COMMUNITY BOARD FEEDBACK PACKAGE

COMMUNITY BOARD RECOMMENDATION FORM

Business Name: Westville HK

Cafe Address: 809 9TH AVE, NEW YORK, NY, 10019

SECTION 1: Site Plan

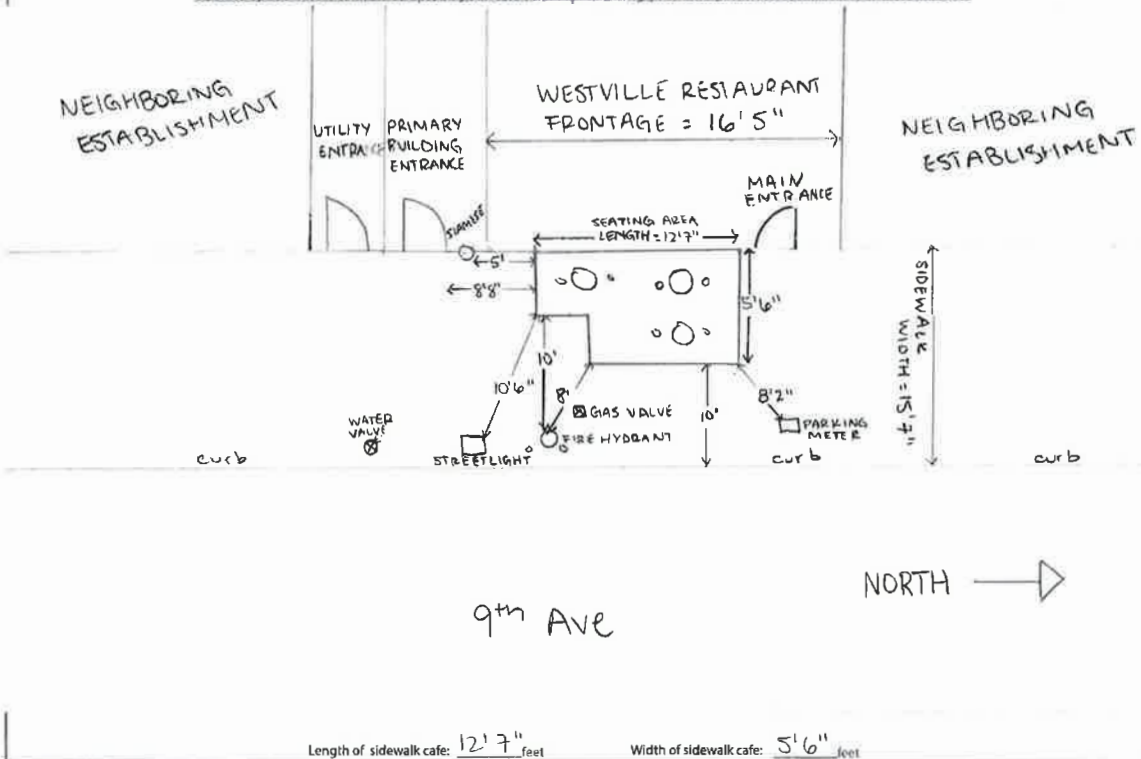
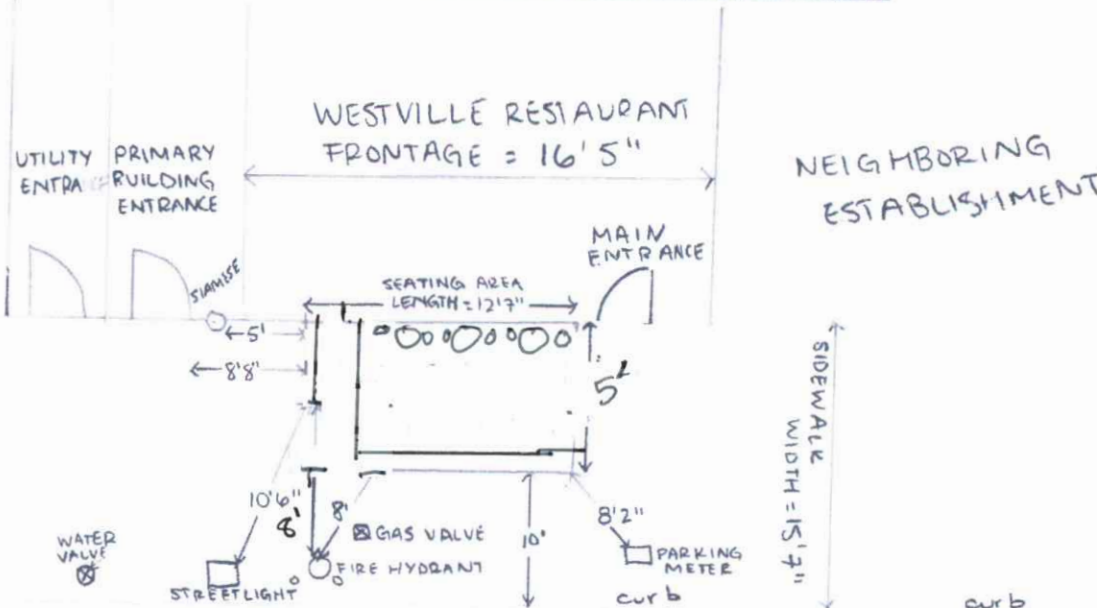
The proposed Site Plan does not provide for the required 10 foot pedestrian clear path. To provide for the required clear path, the applicant has agreed to rearrange the 3 tables with 2 chairs each in this sidewalk cafe. The applicant has provided the attached Revised Site Plan.

To provide for the required 10 foot pedestrian clear path, MCB4 requests the rearrangement of the tables and chairs in the sidewalk cafe. Applicant has agreed to this modification and has provided the attached Revised Site Plan.
